BOUNDARY TREATMENT

CLARIFICATION

Image 1

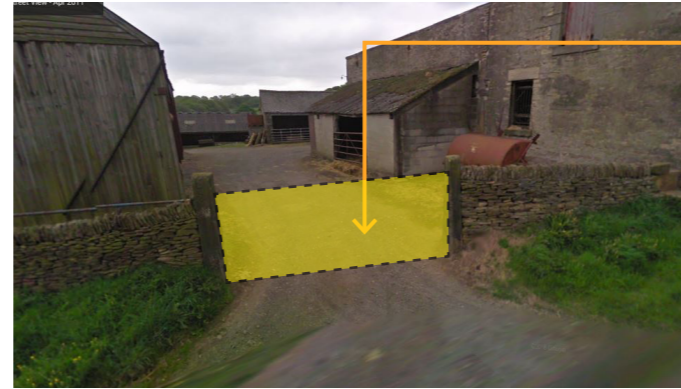
New drystone wall
walling to match and tie into existing stone walling

Image 2

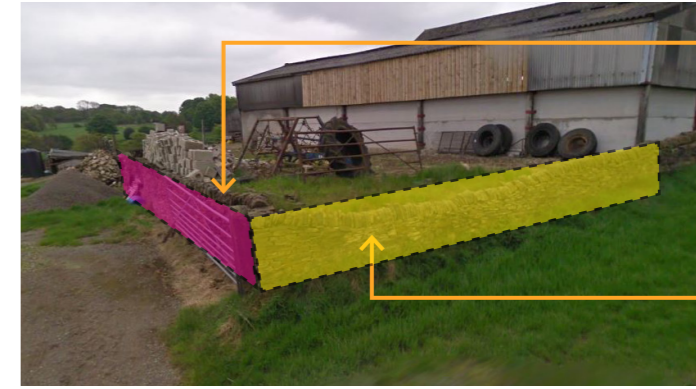
New drystone wall
Walling to match and butt up to existing stone gate posts
